END OF ADDENDUM 2

**PWRC
MULTI-PURPOSE
BUILDING**

5421 ROBERTSON ROAD,
WESTHAM ISLAND, DELTA, BC

Addendum 02

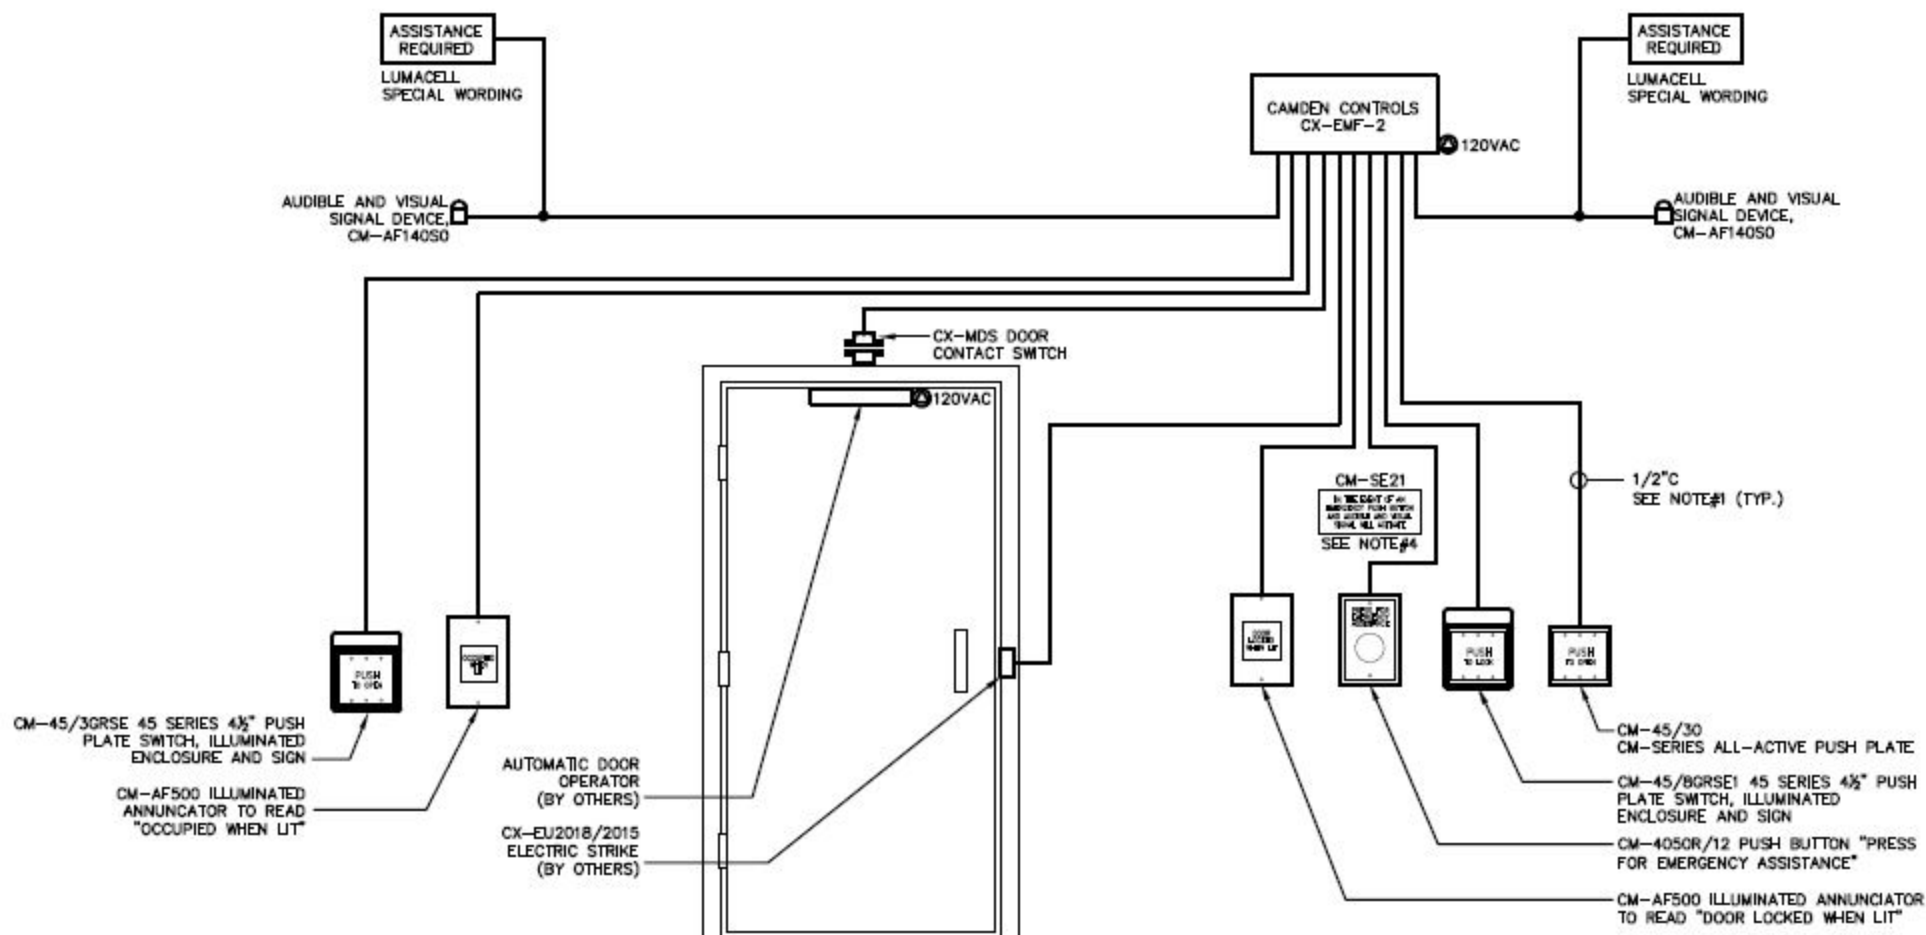
Q: There is no way to determine the existing grade determine the fill thickness required under the slab.

A: Refer to A100a for existing grades and see attached Topographic Survey.

Note that Ground Floor level is at 1.58m.

UNIVERSAL WASHROOM EMERGENCY CALL SYSTEM

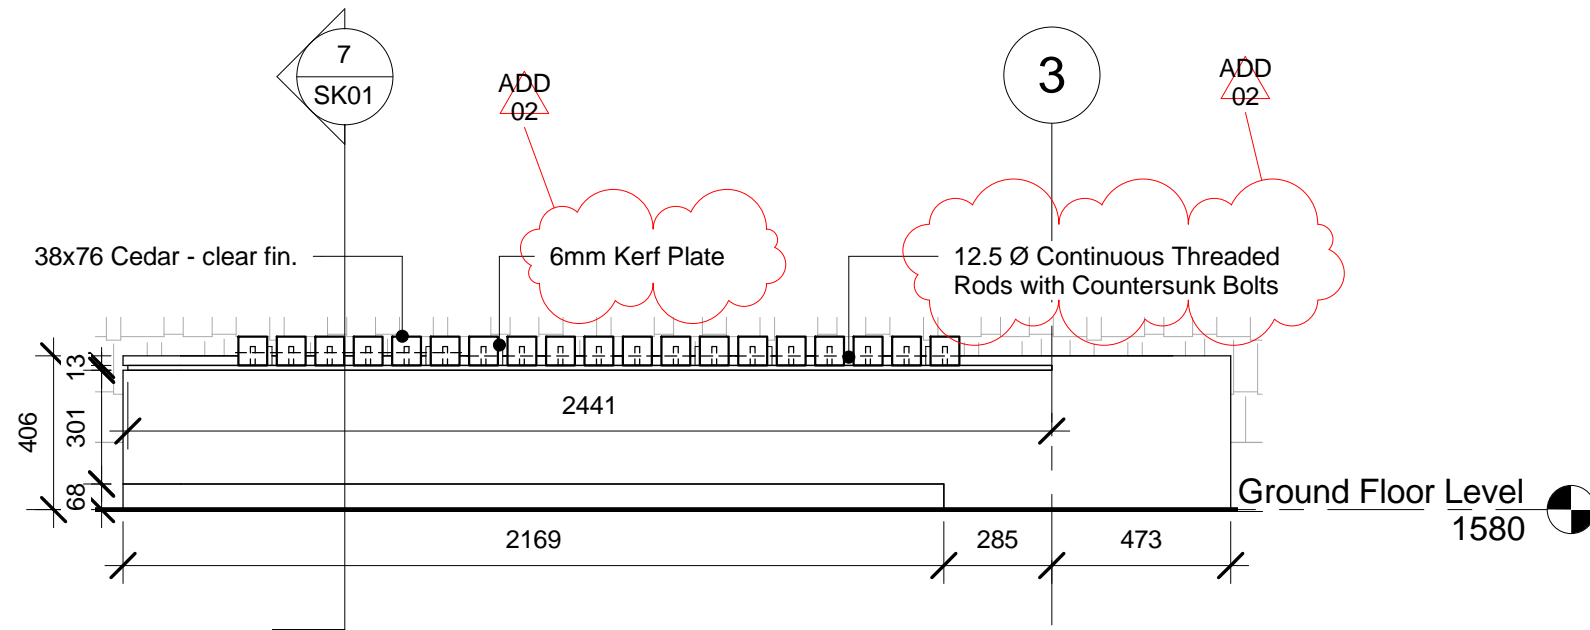
Q: Can the door schedule #D104 & 105 – “Privacy Set with Occupied Indicator” be changed to a Storeroom function (80) lock (see Universal Washroom Emergency Call System attached)?

Clarify intention of washroom electric strike or relay switching. Specifically; hardware note "Provide lock jam integrated into security system & Occupancy sensor..."

A: This is not how washroom doors need to work, for clarity please see answer to question 7.

The intent for Washroom doors is to be automatically locked afterhours. If someone is still inside while this happens the occupancy sensor will detect the person and keep the push button operable from inside.

7 Planter bench detail - Addendum 02
1 : 5

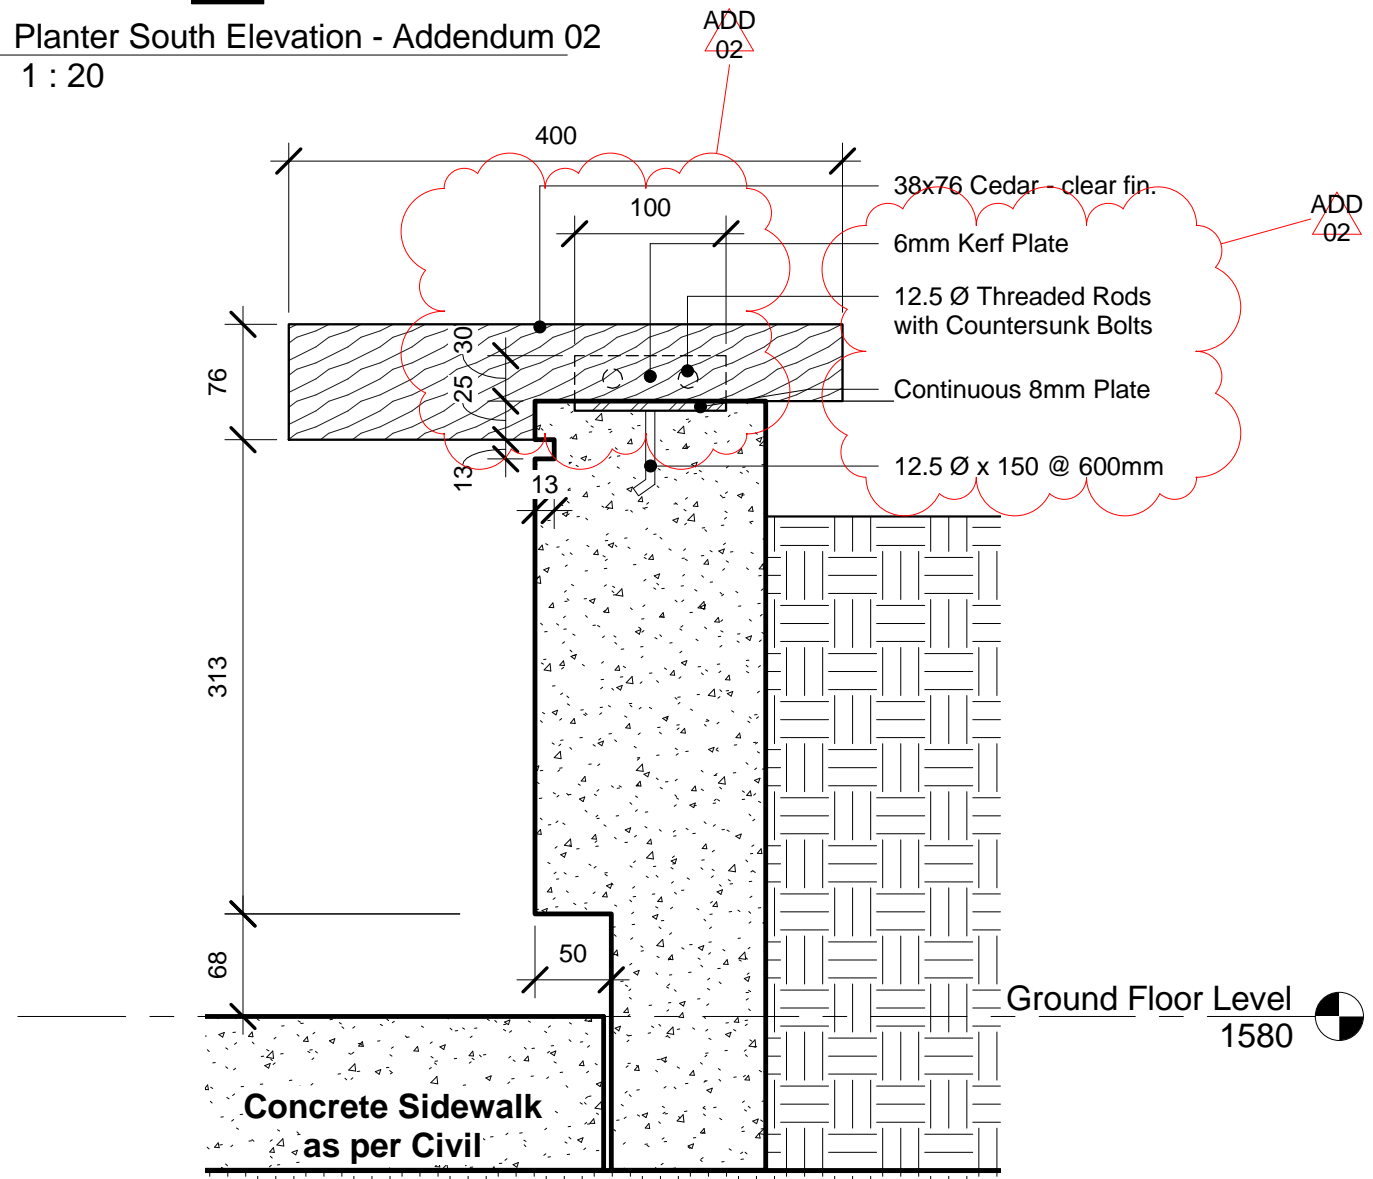
Q: With reference to the Planter Bench as per dwg A406.

Detail 4 – show 125dia be 12.5dia?

Detail 4 – how long is the Threaded Rods with Countersunk Bolts?
Detail 7 – the cast into concrete bent arm – how long and what diameter?
Detail 7 – 6mm steel plate – is this an angle? What size?

A: Please see attached revised Details 4 and 7 on sheet SK01 dated 12th October 2017.
